Re: Petition No. 1230  
Stony Hill Substation Project - Brookfield  
Conditions #2, #3 and #4

**Condition #2:** Eversource is submitting the attached final Site Plan ("Plan") for the Council's review and approval, which details road and substation clearing limits, contours, grading, drainage control and E&S controls".

ATTACHMENT  
Petition No. 1230  
Stony Hill Substation Site Plan

## STONY HILL SUBSTATION SYNCHRONOUS CONDENSER

## PROFILE PERMANENT ACCESS DRIVE

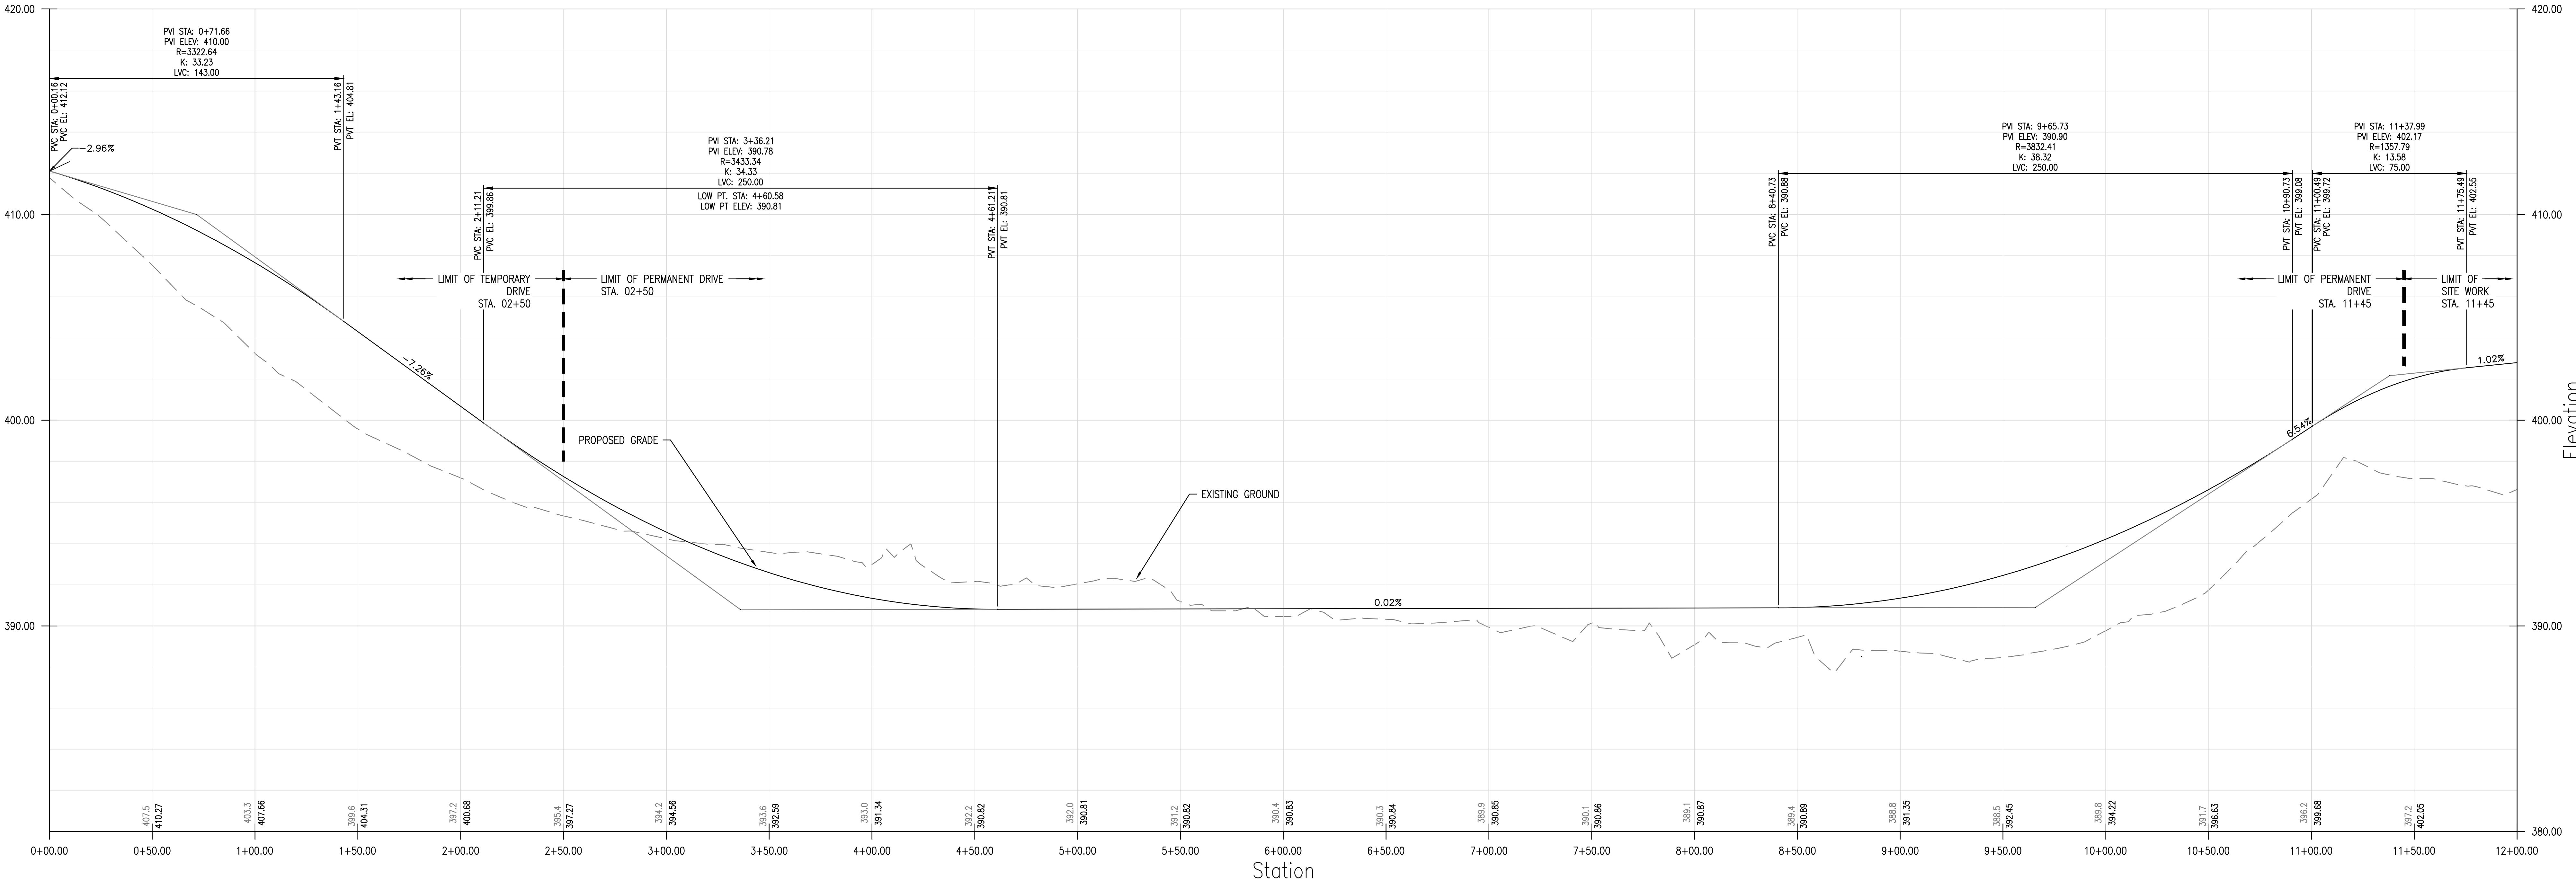
- Improvements to the existing access road on Eversource Property such that there will be created a temporary re-alignment of the existing access to support construction and a final permanent re-alignment prior to the completion of the Project.
- Replacement of the existing Substation 20 foot access gate from Stony Hill Road with a new 20 foot gate. The new gate would be relocated seven feet to the southeast from the existing location.
- Installation of a temporary retaining wall to provide safe vehicular travel on the temporary road during construction. The retaining wall would be removed after the installation of the permanent road.

In addition, the proposed permanent access road alignment requires modification of the approved Substation expansion area:

- An angled entrance to the eastern side of the expansion area at lower grade resulting in a curved northeast corner and reduction in height and fill for the northeast corner slope.
- Slight alteration of originally proposed fence line on the southeast side of the approved expansion area.

TYPICAL RIPRAP SLOPE SECTION

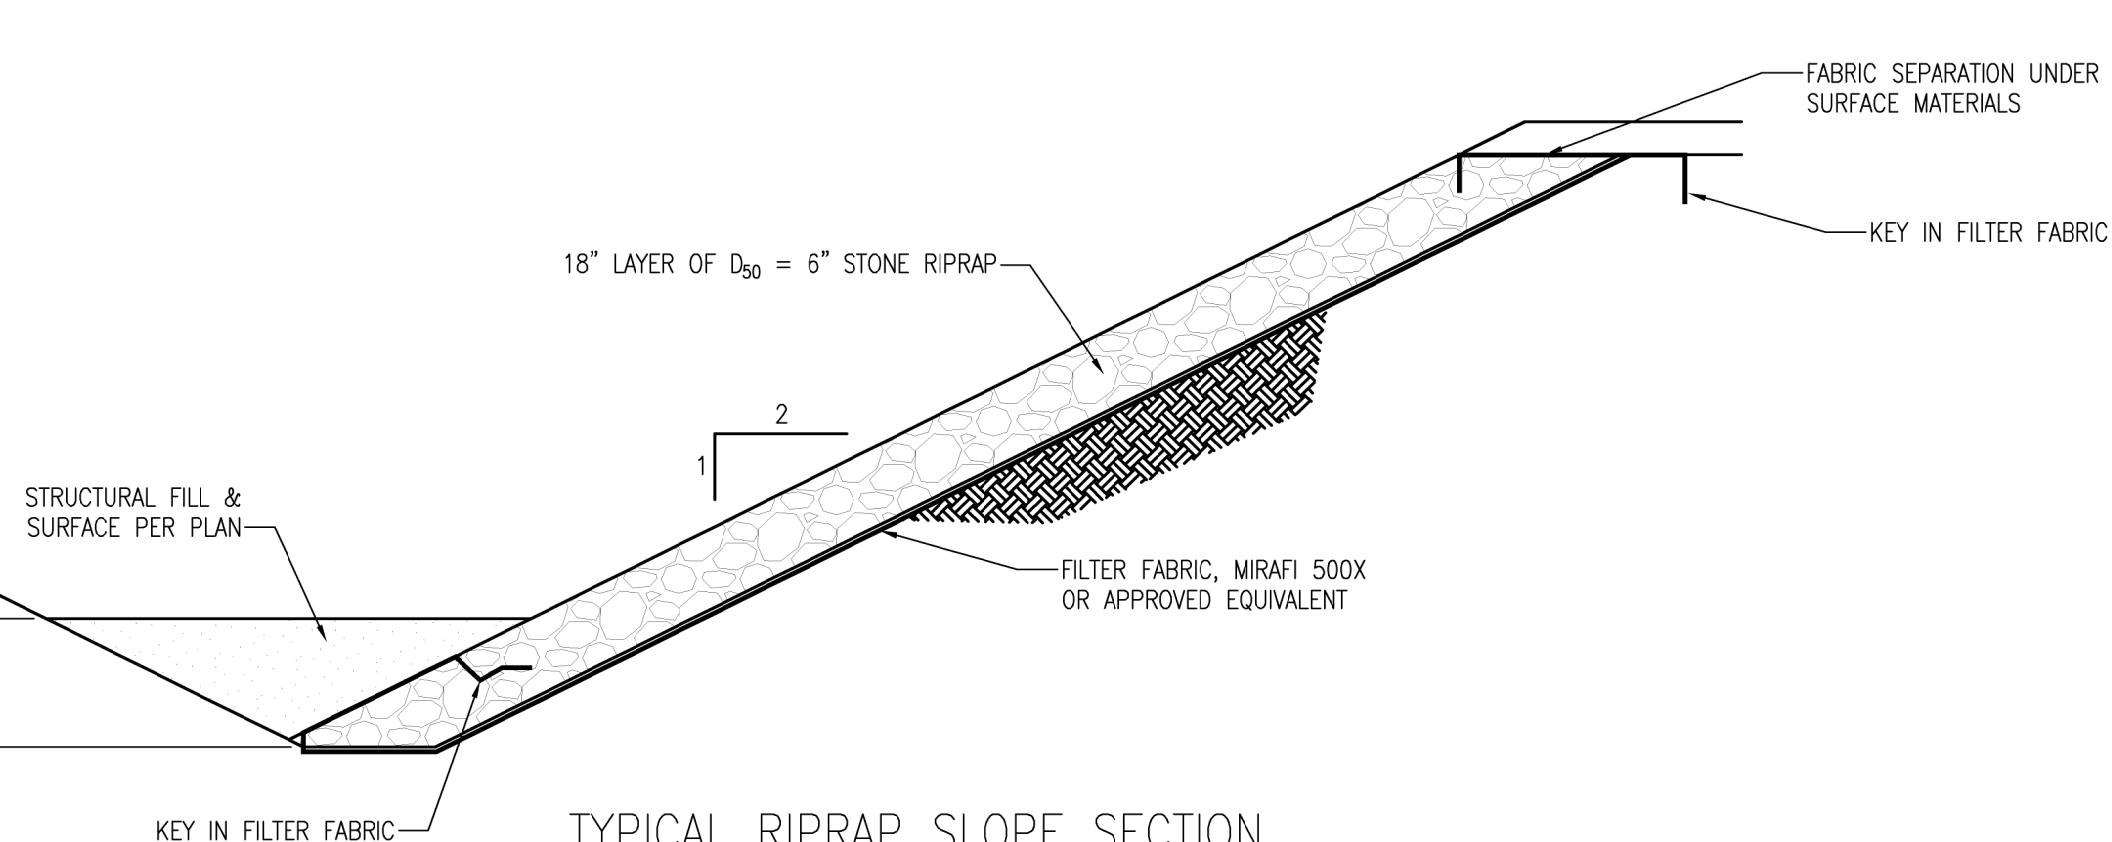
**Condition #3:** Eversource evaluated the re-use of "on-site material for slide-slope armoring" and determined the on-site material is not feasible because it is susceptible to erosion and does not provide the required stability.
